PROJECT: Summerlin West Village 30A - Rough Street Grading -  
Update #1

| <b>SUBJECT:</b><br>Drainage Study for:<br><b>Summerlin West Village 30A – Rough Street Grading –<br/>Update #1</b> |                                           | <b>COPIES TO:</b><br>Atkins                                                                       |

#### 2<sup>nd</sup> Submittal: Update to add improvement plans with riprap for erosion protection

Rough Grade Technical Drainage Memo Update

**PLAN AND PROFILE - LAKE MEAD BOULEVARD (SOUTH) BEGIN TO STA 16+50**

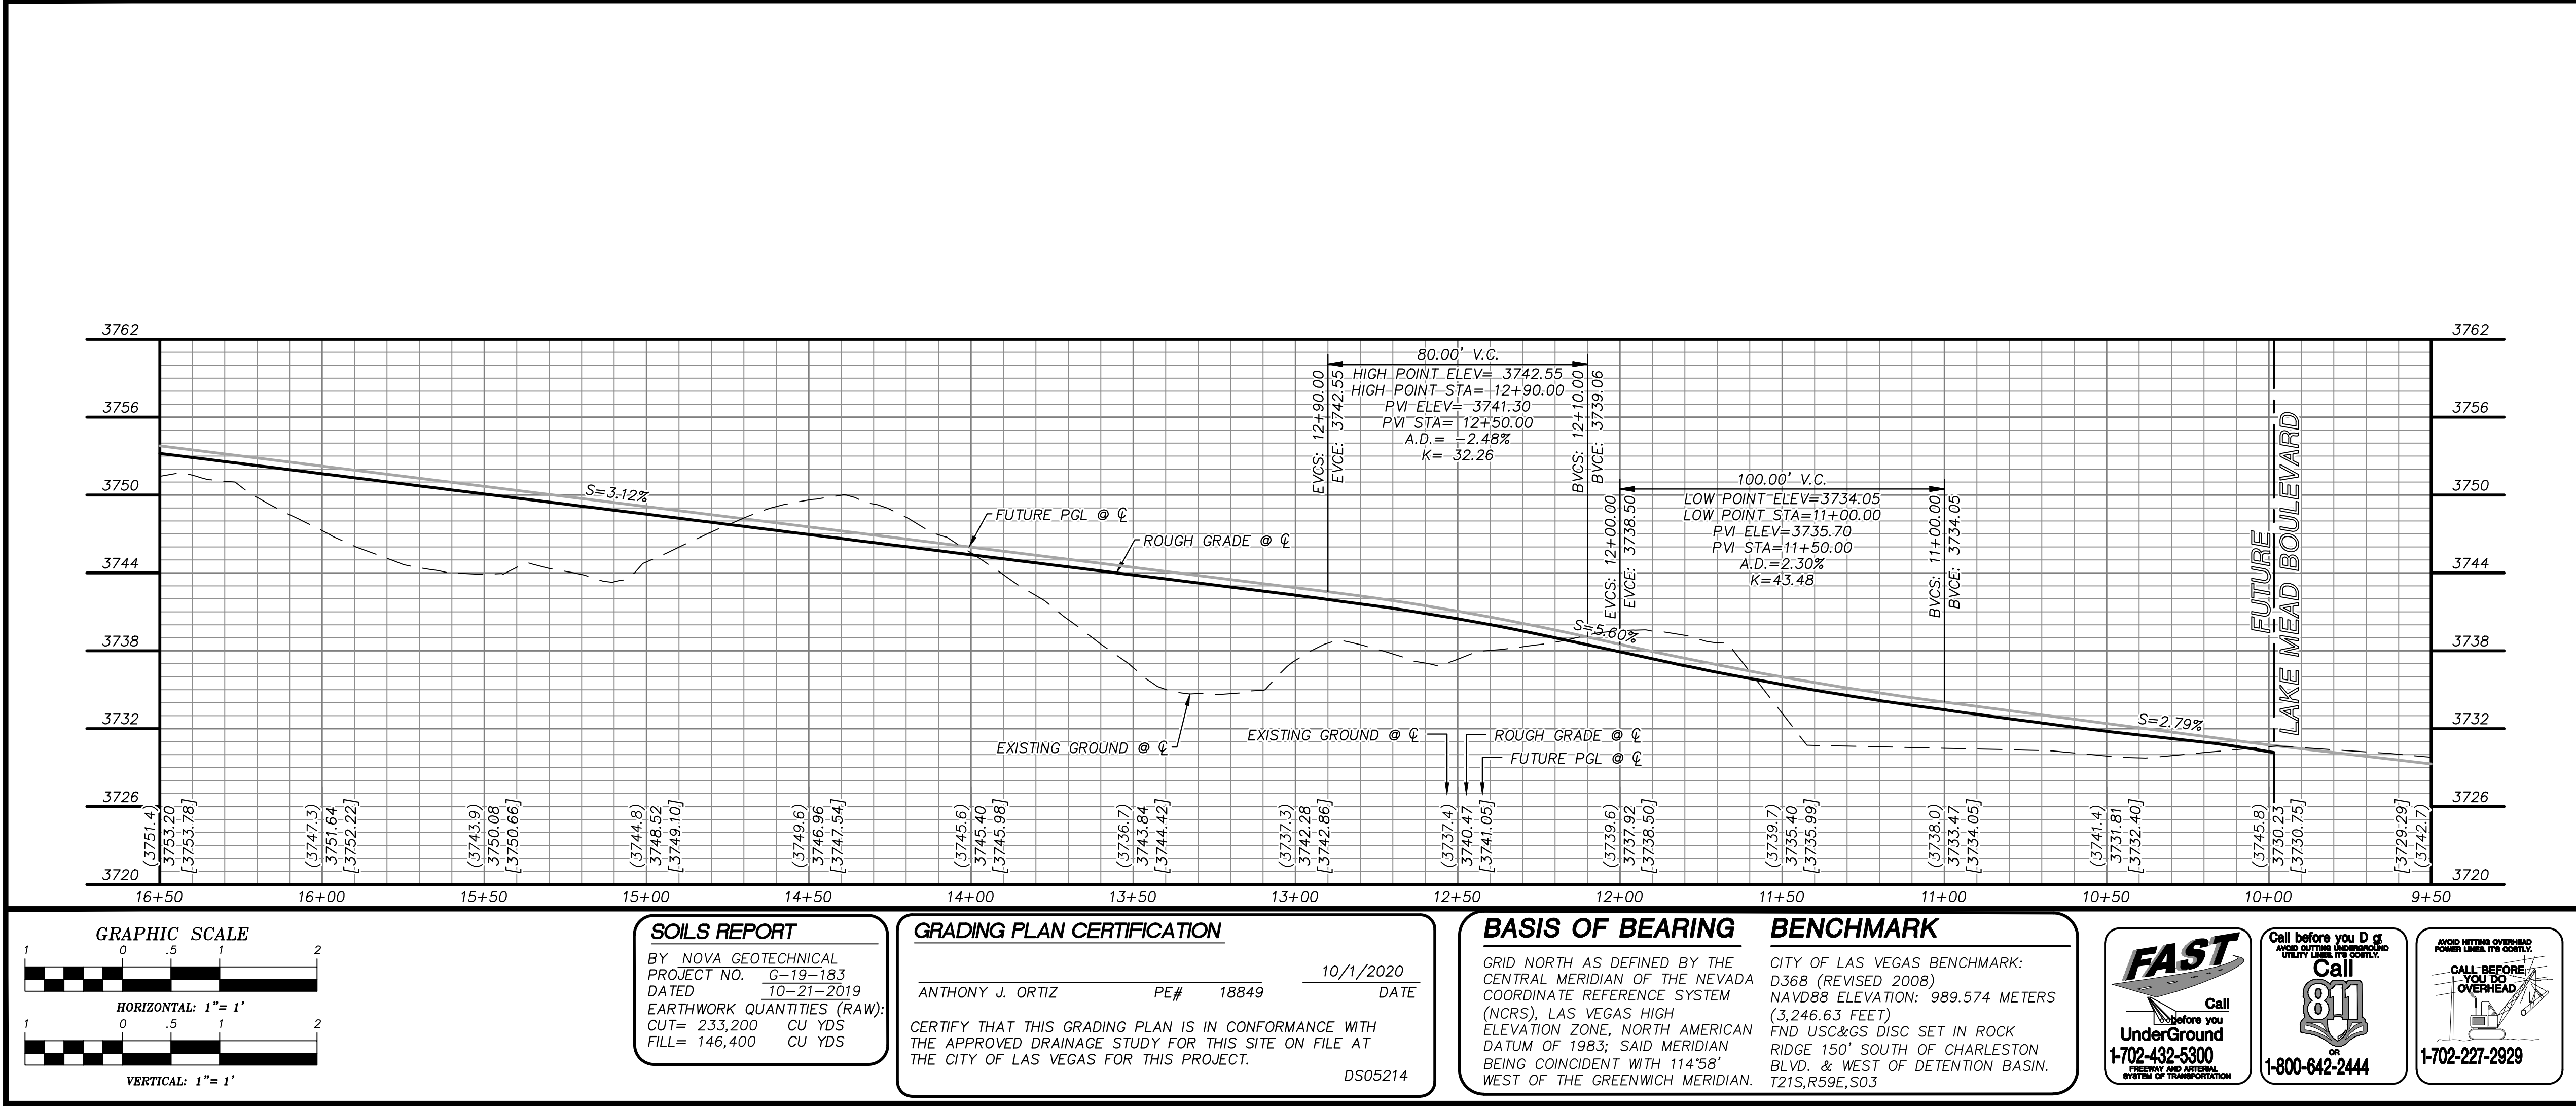
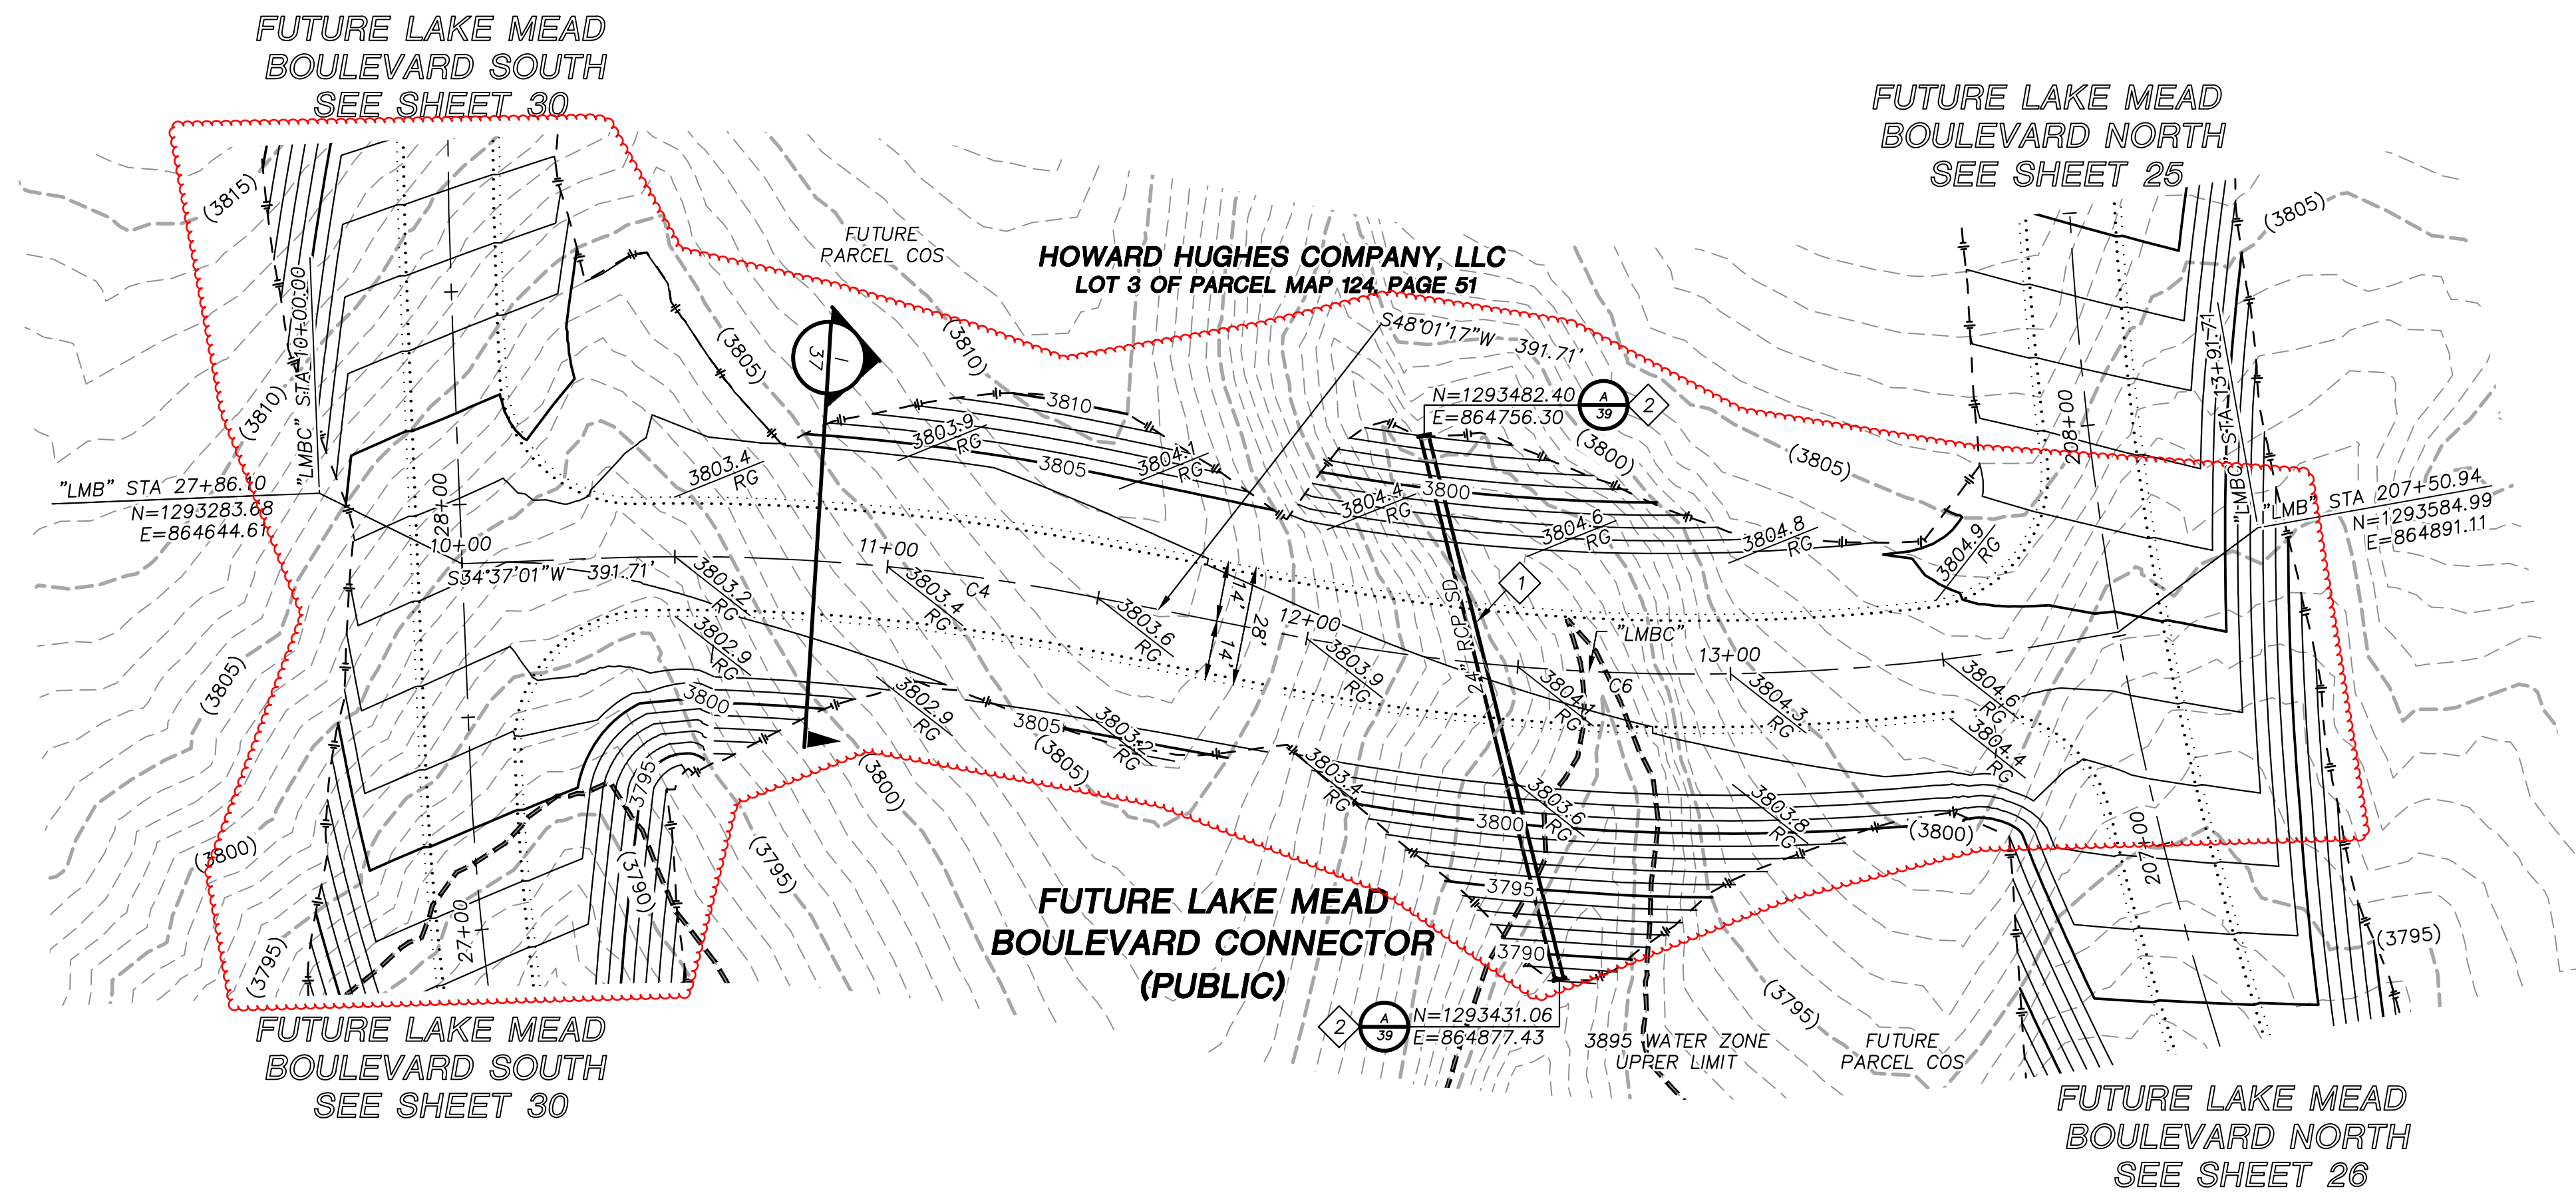
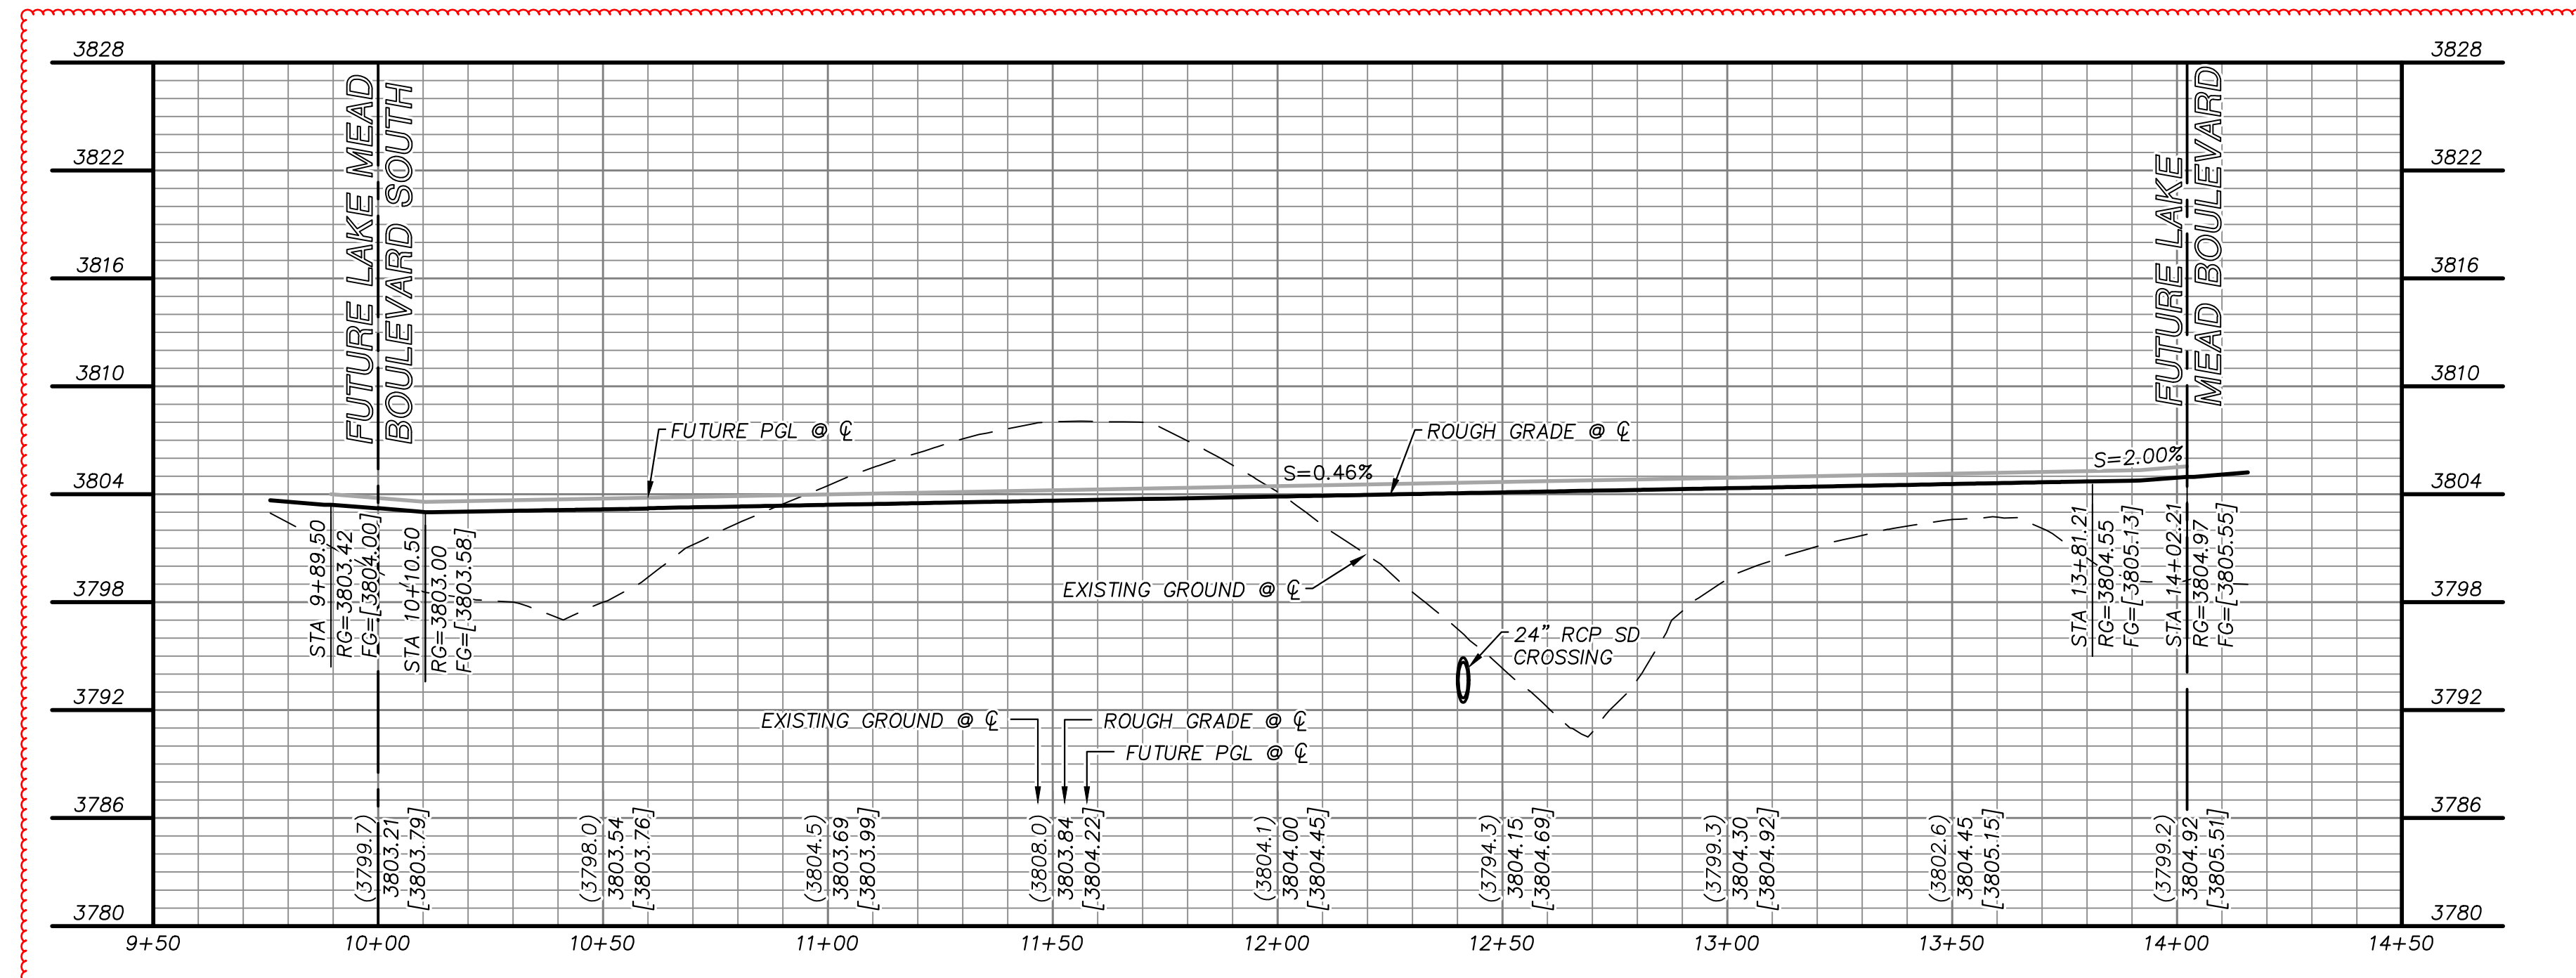
1. In all pertinent improvement plans storm drain construction notes, revise the thickness of riprap to be two times of the D<sub>50</sub> size. Construction Notes #5 to #9 showed only 1.5 times are not adequate. Review and revise accordingly.
2. The approval of this drainage study is for the issuance of rough grading permit for future streets and temporary construction access only.
3. Howard Hughes Company (Summerlin) is solely responsible for the maintenance and erosion control of the interim facilities.
